MEMORANDUM

To: Salt Lake City Planning Commission
From: Katia Pace, 801 535-6354, katia.pace@slcgov.com
Date: April 27, 2022
Re: PLNPCM2021-00898, 1301 S State Street - Coachman Mixed Use - Planned Development

Planned Development (Continued Item)

ACTION REQUIRED: Consider modifications made to the proposal in response to discussion and comments made at the December 15, 2021, Planning Commission meeting. The Commission tabled the item to a future date and requested clarification on the unit mix, confirmation of a vehicular access from UDOT at State Street and asked the applicant to consider additional changes to the façade to make it more pedestrian friendly

Previous design

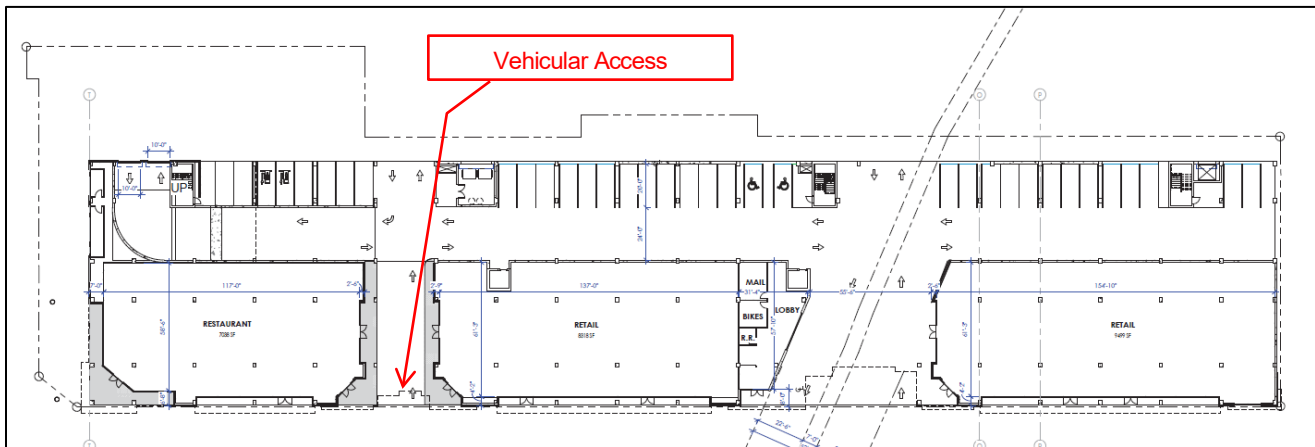
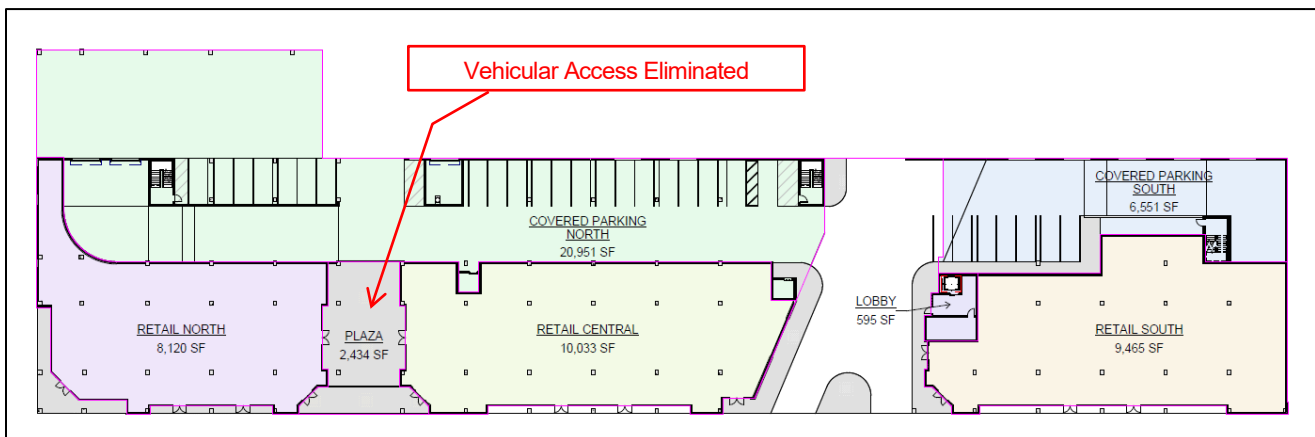
The Planning Commission expressed a concern that the proposed access points to State Street had not yet been approved. UDOT has reviewed the proposed vehicular access from State Street, a UDOT road, and the project overall. Staff has discussed this proposed project with them and UDOT has no objections to the proposed access. However, UDOT will not give final approval until after the Planning Commission has approved the project.

The current proposal eliminates a second driveway approach from State Street. UDOT likes to keep the driveway approaches to a minimum to keep the traffic flowing on UDOT roads. The applicant agreed to eliminate the second access point. Beyond crossing a street, conflict points between cars and pedestrians occur at driveway access where cars cross pedestrian paths. Too many accesses crossing the sidewalk create a very unfriendly environment for pedestrians. The elimination of the second access helps create a better pedestrian experience.

Findings: A condition that UDOT approves the access points and the design as part of the building permit process has been added.

Previous design

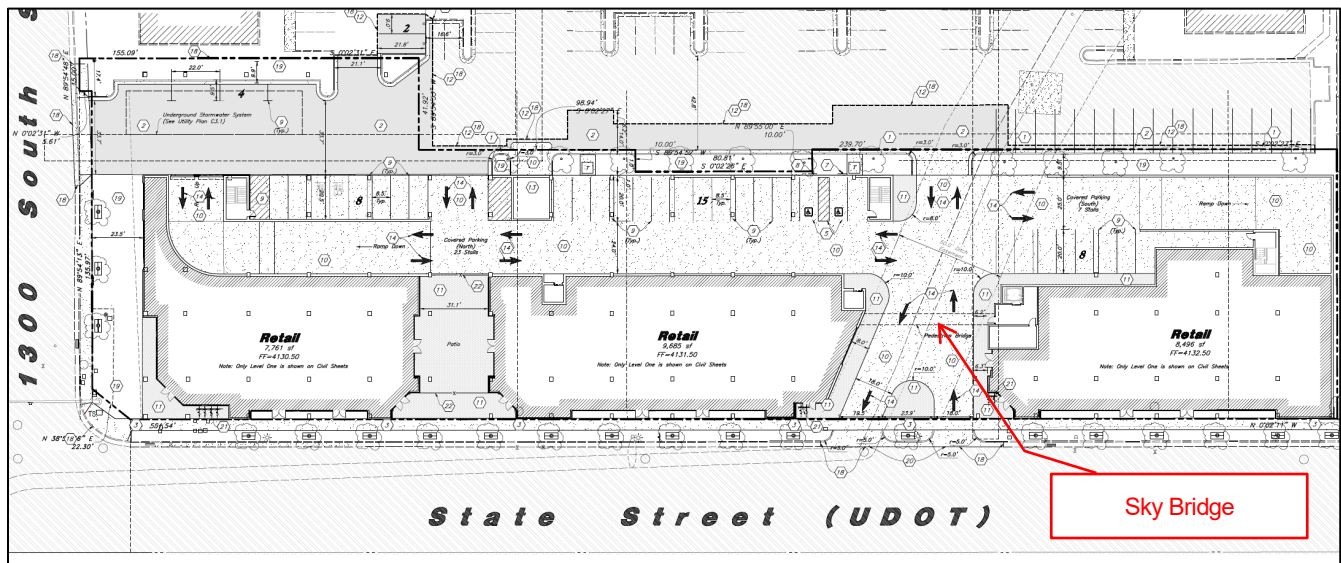
At the public hearing on December 15, 2021, the Planning Commission found that the proposed building would be too long as proposed and requested that the applicant break up the extensive façade of the building. The commission suggested to split the building into two buildings, or to include a courtyard to create the effect of the building being perceived as two or three buildings.

In response to the Planning Commission comments, the applicant modified the design of the project by splitting the building into two buildings connected by a sky bridge and adding a courtyard on the ground floor of the North Building. The length of the North Building is proposed to be beyond the allowed 200 feet, at approximately 335 feet.

The revised design maintains the previously proposed modulation, materials, fenestration/balconies, and a mix of uses at the ground level that would have a generous percentage of glass. Also, the closeness of the building to the front property line along with trees aligning the street would help to engage sidewalk activity, providing visual interest and variation for pedestrians.

Findings: The modified design breaks down the massing of the building to a more human scale that emphasize the human scale by splitting the building into two building and adding a courtyard to the North Building. The building massing is broken up and is designed to maintain compatibility with surrounding buildings, some of which are smaller in scale.

ISSUE 3 Parley's Canal

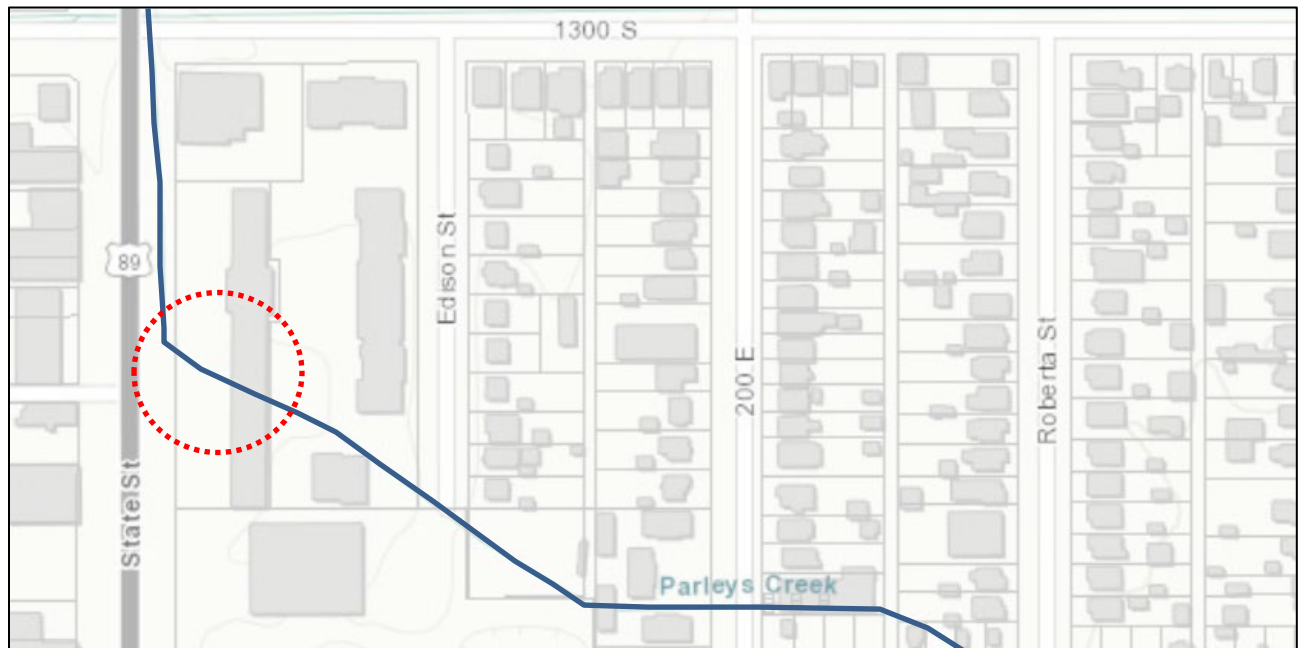
Parley's Creek starts at Mount Dell Dam and Reservoir and empty into the Jordan River. It's mostly underground. At the site for this development, Parleys Creek runs through a concrete culvert. The proposal is to build around the creek with a vertical 16 ft. clearance from the area where the culvert is located and a 15 ft. horizontally clearance away from each side of culvert.

Salt Lake County Flood Control has issued a temporary permit and a final permit will be based on construction drawings. Additional conditions may be required when plans are submitted.

Staff recommends that the Planning Commission give the staff the ability to make necessary modifications to the approved plans to meet the technical requirements imposed by the County Flood Control. An alternative is for the commission to create a condition that any changes to the plans created by Flood Control be brought back to the Planning Commission as a major modification.

ISSUE 4 Setback on 1300 South

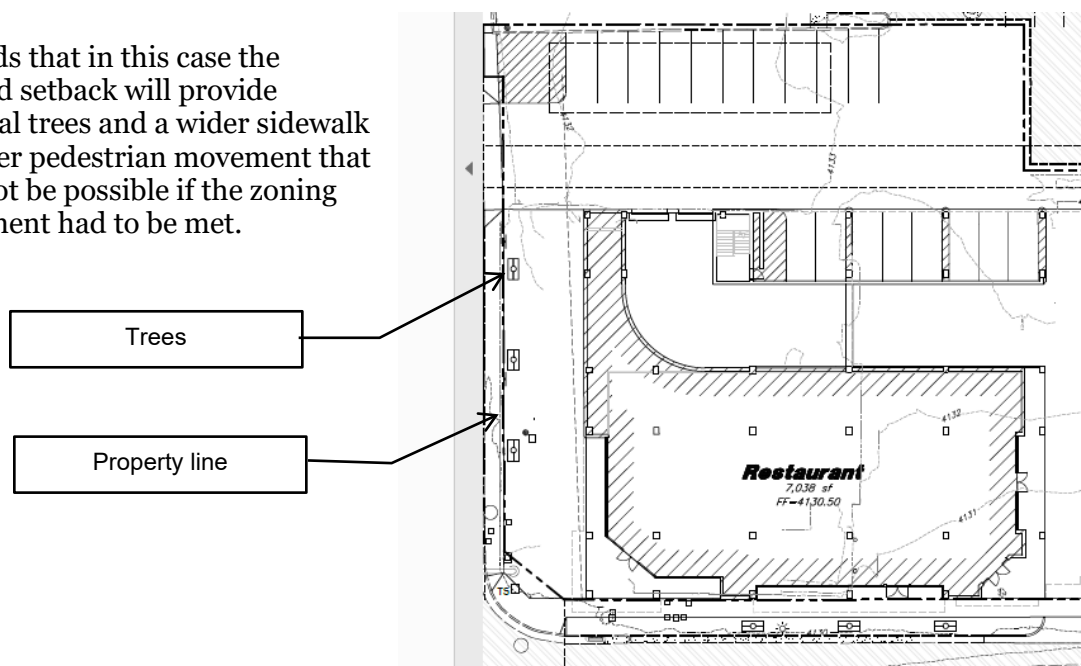
The other requested modification is to have the building façade facing 1300 South to be built 23 feet from the property line. The maximum corner yard setback is 10 feet with a minimum of 50% of street facing facade having to be built with no setback. Locating new buildings at or near the front property line helps to engage sidewalk activity, providing visual interest and variation for pedestrians. However, the front yard facing 1300 South will need to be extended beyond the 50% maximum allowed because of existing power lines that will prohibit construction under it. Also, the sidewalk on 1300 South is approximately 5 feet with a tight room for pedestrian movement. The applicant is proposing a 23-foot setback to provide a pedestrian walkway with trees along the sidewalk.

Staff finds that in this case the increased setback will provide additional trees and a wider sidewalk and better pedestrian movement that would not be possible if the zoning requirement had to be met.
